ENVIRONMENTAL REVIEW TEAM REPORT

**CHURCHILL PARK EXPANSION
NEWINGTON, CONNECTICUT**

APRIL, 1983

SIMPLIFIED SITE PLAN

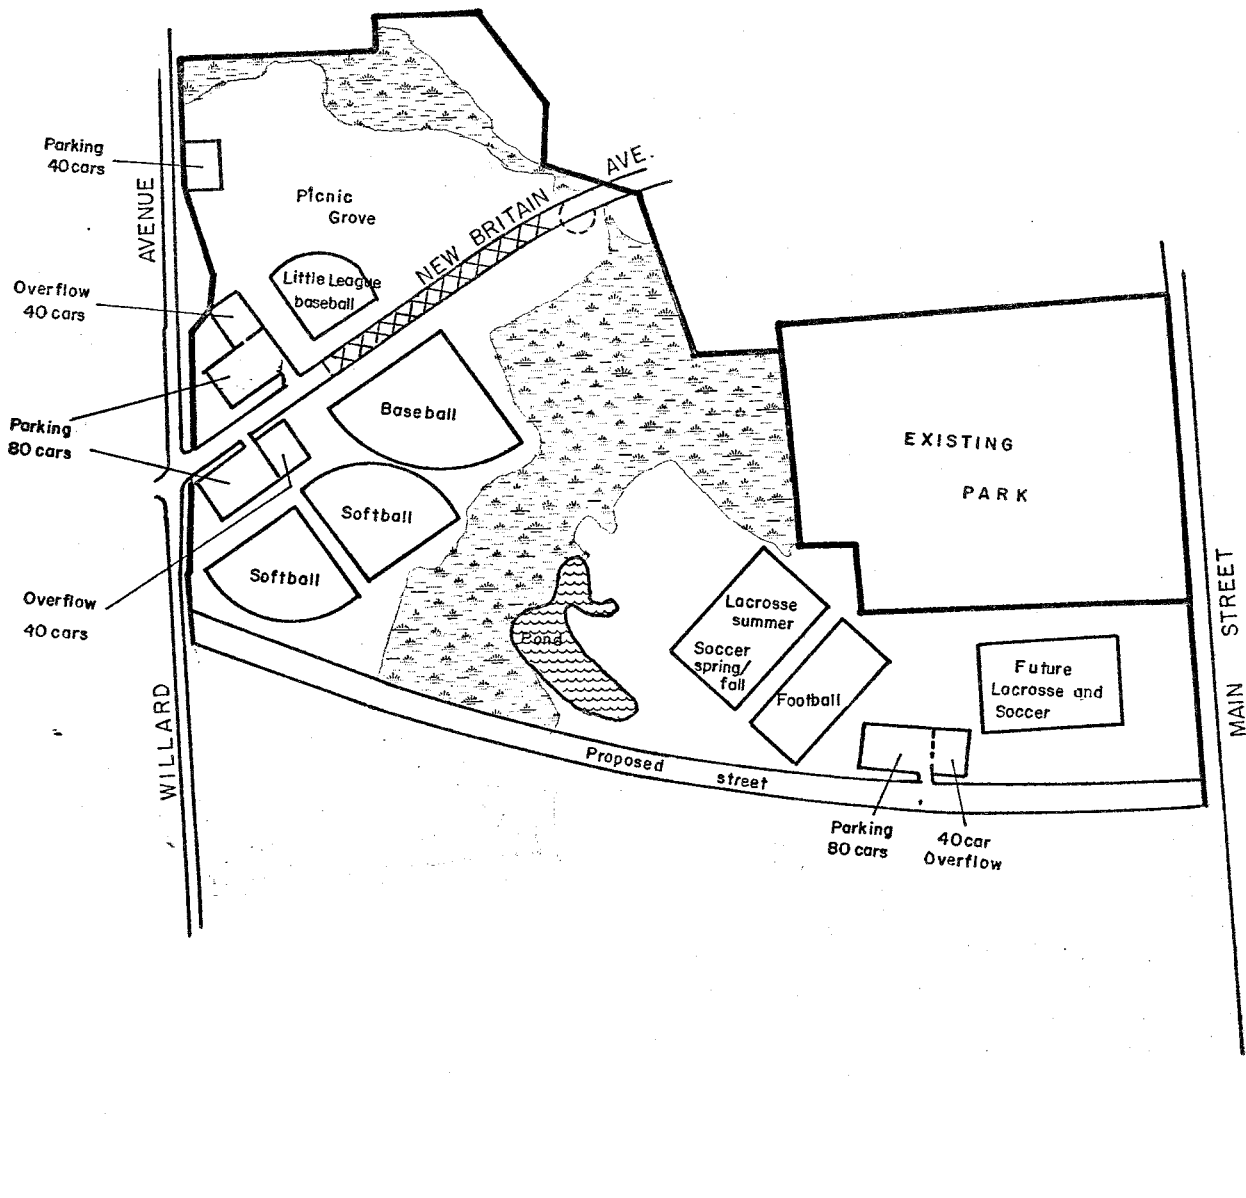
- 8) In the opinion of the Team Planner, the proposed site plan makes good (non-disruptive) use of the terrain features and is a practicable plan for development of the property. Treed areas are offered via the picnic grove and wetland areas while the basically open field areas, which are comparatively level, are proposed for ball field construction thereby minimizing site alteration via tree cutting and earth moving. Some cutting and filling is proposed to accommodate the playing fields but not on a scale which, if properly done, would have a markedly negative impact on the nearby wetland situated in the middle of the new park.

Prior to discussing each of these areas in some detail, an overall recommendation would be to develop the Park in phases to minimize erosion and sedimentation from wind and water. This is needed because of the proximity of private single family homes, condominium complexes and wetlands.

There are two general activities proposed in this area: 1) constructing the ball field and parking lots, and 2) the development of a picnic grove. As discussed previously, the major soil types are Manchester gravelly sandy loam 3 to 15 percent slopes and Hartford fine sandy loam 3 to 8 percent slopes. The proposed picnic grove is mostly in the Manchester soil area and is presently forested. It would be desirable to construct an access lane up to the proposed picnic grove for park maintenance. Also a small parking area should be considered in this area which will allow cars to drop off elderly or handicapped persons who are unable to walk up the steep slopes to the picnic area from the lower parking lot. Any access lanes and/or parking areas should be constructed to minimize erosion from these steep slopes. Construction of a pavilion and/or picnic shelter may necessitate excavating into the steep slope. Since the Manchester soils are gravelly, there is a tendency for cut banks to cave in. A suggestion is to stabilize all disturbed areas as soon as possible using a drought tolerant grass mixture such as 25 lbs. Kentucky 31 Tall Fescue and 25 lbs. Creeping Red Fescue per acre. Mulch with straw or hay and on steep slopes anchor the mulch with erosion control netting. The information sheets presented in the Appendix of this report provide additional seeding information.

The dominant soils in this area are excessively well drained. There is a small area of moderately well drained soil in the proposed parking area. Fill material may be needed there to provide a suitable base for either a gravel or paved parking lot. The soils in this area are well suited to the softball and baseball fields. Since the soils are excessively drained, however, irrigation may be necessary in the summer.

Grading work will be needed in this area to provide a level surface for the ball fields. Topsoil should be stripped, stockpiled and either temporarily seeded or surrounded by hay bales at the base of the stockpiles. These measures will reduce any potential of the topsoil eroding. Following final grading, this topsoil should be spread on the surface of the disturbed area and properly seeded, limed, fertilized, and mulched. Hay bales placed along the boundary of the wetland soil will help to trap sediment emanating from construction of the ball fields. Should these fields be constructed during unfavorable seeding periods, temporary cover should be used to stabilize the site from the effects of wind and water erosion.

This area contains an old gravel bank with a steep unvegetated slope. The slope should be vegetated and surface water runoff directed away from the proposed athletic fields. The construction activities should be carried out as suggested for Area B to minimize erosion and sedimentation. Fill material may be needed to construct the lacrosse field. The pond area is a suitable site for a dugout pond and will be fed primarily by groundwater and springs. The water level may fluctuate during long dry periods because of the fluctuating groundwater table. The pond should be sized and designed to satisfy any future irrigation needs of the athletic fields, unless groundwater wells are to be drilled for such purposes.

As shown in Figure 2, a new street is being proposed along the southern edge of the property. Storm water runoff outlets with plunge pools would assist in dissipating flow from the road. The soils directly to the east of Willard Avenue may serve as excellent fill material for the road base. Proper measures such as haybales, culverts and vegetative stabilization of the area of the proposed road will reduce any sediment flowing into the wetland.

The proposed site plan reviewed by the Team makes good (non-disruptive) use of the terrain features and is a practicable plan for development of the property. Treed areas are offered via the picnic grove and wetland areas while the basically open field areas, which are comparatively level, are proposed for ball field construction thereby minimizing site alteration via tree cutting and earth moving. Some cutting and filling is proposed to accommodate the playing fields but not on a scale which, if properly done, would have a markedly negative impact on the nearby wetland situated in the middle of the new park.

It is hoped that the new road proposed for the south portion of the park and crossing the wetland, would be constructed with an eye to either screening from or softening its starkness from park users by the use of trees and shrubs. A landscaped boulevard here would give the road the appearance of being a part of rather than something apart from the rest of the park. Through proper landscaping, the visual and noise impact of the new road would be somewhat softened. Bridging over the wetland would, of course, preclude plantings at the point of crossing but such plantings would be possible on the approaches where the road-sides consist of soil. If, on the other hand, the wetland roadbed is to be made of fill rather than a bridge, the full length of the embankments could be planted.

The picnic grove proposed for the northwest part of the park is appropriately sited. Some consideration should be given to providing drive to access to some of the picnic tables. The elderly and others with diminished mobility would be better accommodated thereby. A grouping of tables adjacent to a small parking lot (say 10-20 cars) would accomplish this. A small number of parking spaces reserved for these users should suffice. Closure of New Britain Avenue should enhance the possibilities for development of picnic areas here. Park roads providing through access to the town roads are specifically not recommended for the reasons stated for New Britain Avenue. The undergrounding or elimination of utility lines along the stretch of New Britain Avenue to be closed off would greatly enhance the appearance of the park and the opportunities for snag-free kite flying would also be somewhat enhanced.

FIGURE 3 WATERSHED MAP

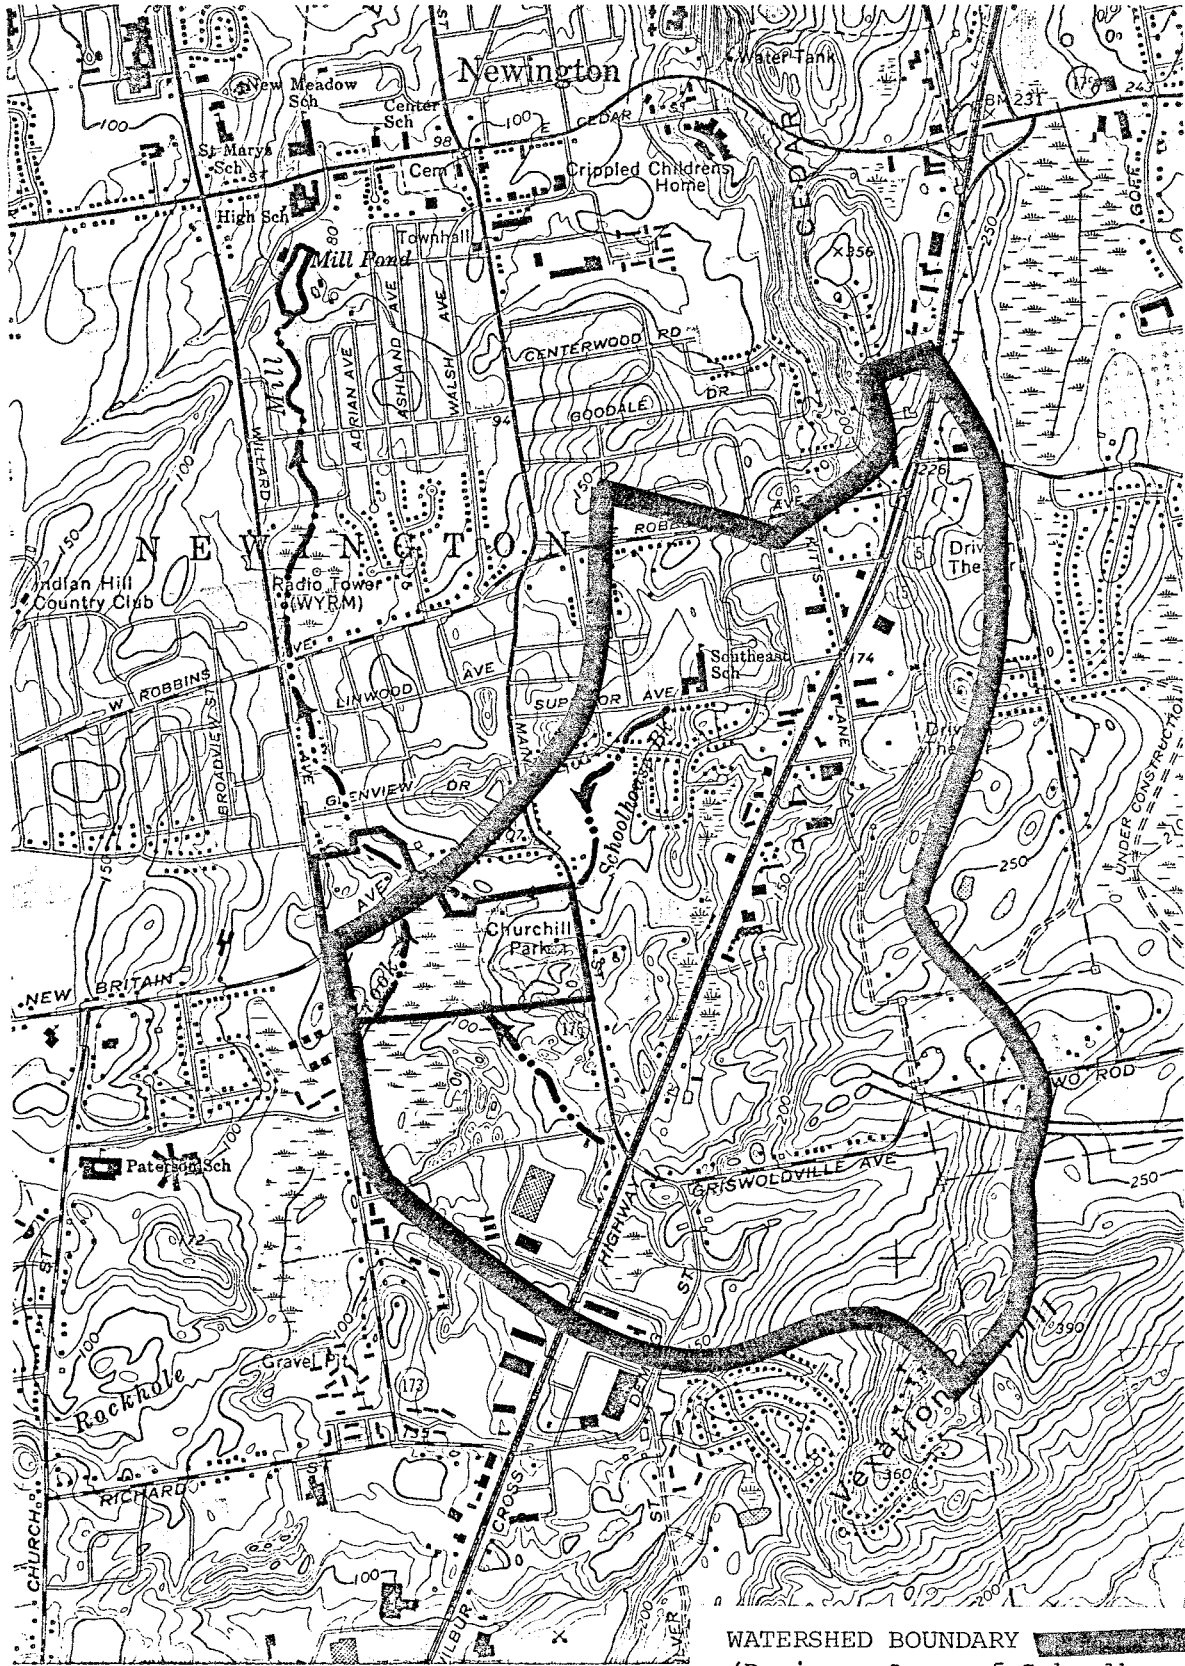
As stated previously in the Geology section of this report, the central wetland on this site is about 30 acres in size. This wetland serves as a natural storage area for stormwater runoff from the surrounding areas. As a result, peak flood flows are lessened down stream. The proposed Park plan which leaves most of this wetland undisturbed will help to protect this valuable flood control function.

The proposed recreational facilities and parking lots will not result in noticeable increases in stormwater runoff if they are constructed entirely of previous surfaces as planned (e.g. gravel packed trails and parking areas, and vegetative cover). As discussed previously, provisions should nonetheless be taken for effective erosion and sedimentation control during project construction.

Increases in runoff can be expected from construction of the proposed road at the southern border of the property. This increase in runoff results from the creation of an impermeable surface on the site (i.e. the paved road). It is anticipated that most of this runoff will be discharged to the central wetland area on the site. The increased runoff should not have a significant effect on the hydrology of the wetland provided: 1) stormwater runoff outlets with plunge pools are appropriately placed to dissipate the flow from the road, and 2) proper erosion and sedimentation controls are implemented to minimize sediment flow to the wetlands. Erosion and sediment controls will be particularly important in the construction of the road through the wetlands. It will also be important to place culverts properly (if a bridge is not built) so that the hydrologic flow through the wetland is not interrupted. Alterations of the water level in a wetland can significantly impact the existing flora and fauna.

VEGETATION TYPE MAP

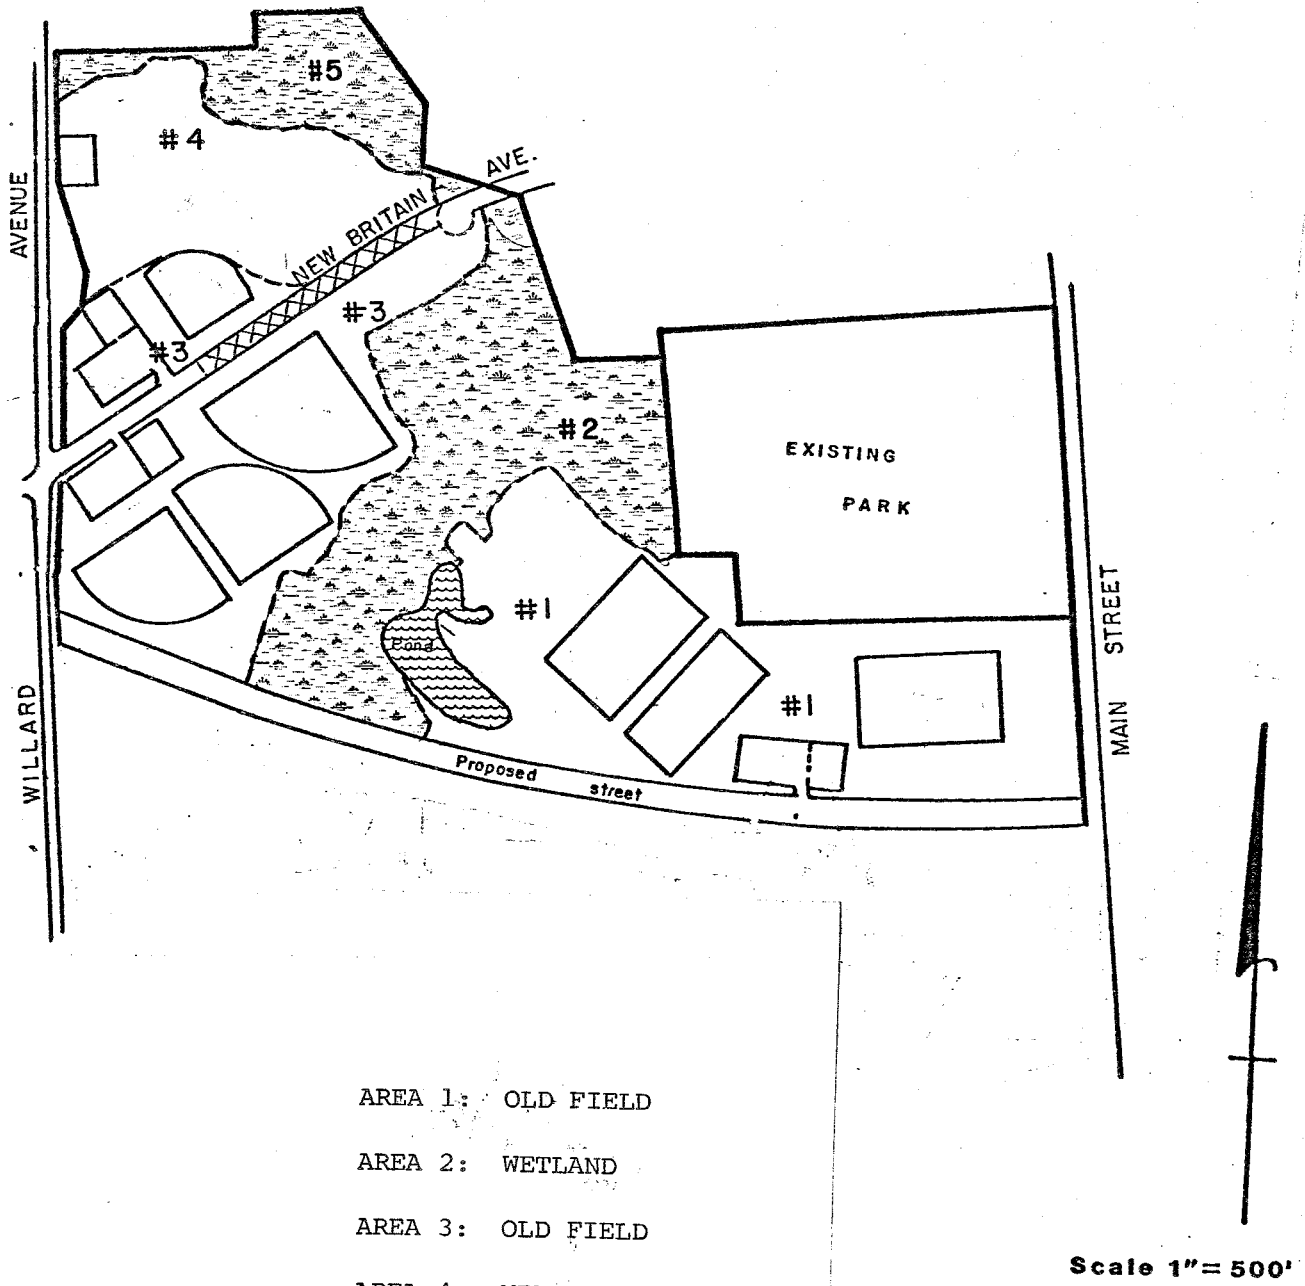
AREA #1 - lies south of the existing Churchill Park and contains the future lacrosse and football fields. This area was at one time a combination of gravel bank and wetland soils. At present the wetter soils are covered by fill brought in for what once was to be the I-291 by-pass. Present soil conditions are poor due to fill characteristics. Vegetation varies from impoverished grasses and pioneer tree species such as red cedar, aspen and locust to pockets of wet areas containing cattails, weeping and pussy willow and speckled alder.

AREA #2 - is identified on the proposed plan as a wetland-marsh natural area. This area is either open water or has the water table very close to the surface of the ground. Hummocks of grass exist along with cattails, bull rush, speckled alder and scattered red maple.

AREA #3 - straddles New Britain Avenue and is a typical old field. A portion of this area was at one time a nursery. Natural vegetation present includes a variety of grasses and weeds, sapling and pole sized red maple, red cedar, locust, sumac, aspen, bayberry, red osier dogwood, multiflora rose and crab apple. Remnants of the old nursery stock include pin oak, white spruce and Norway maple.

AREA #4 This parcel has been designated as a future picnic area under the plan. This forested piece contains a variety of tree species. On the top of the knoll common species include large stems of beech, red and white oak, sugar maple, and black birch. Side slopes contain the same species but also include black cherry and tulip poplar. The understory is primarily made up of seedlings of sugar maple, beech, and black birch.

There are several conditions present which will influence the potential for design and maintenance of vegetative cover. Wetland soil types (primarily cover types 2 & 5) have a water table very close to the surface of the ground. This allows for shallow root penetration and as a result, windthrow is a potential hazard. Openings and clearings in and along side wetland areas should be avoided if possible.

The present natural vegetation will probably only be recognizable in cover types 2, 4, and 5 after implementation of the plan. Of these, 2 and 5, due to their inherent wetness, are slated for natural areas. These wetland areas will be important in helping to add natural color and beauty to the park, as well as in providing a unique habitat for wildlife. Protection of these areas is an important component of the Plan.

A maintenance Plan for the proposed picnic area should be developed. Of concern here are the beech trees, many of which are decadent. Obvious signs of rot exist along with many dead limbs in the live crown. These are considered hazardous and do not belong in a heavily used recreation area. A mixture of tree and shrub species should be encouraged at the picnic area. Different stems offer a variety of color, foliage, wildlife habitat and to some extent protection from potentially devastating insect and disease infestations.
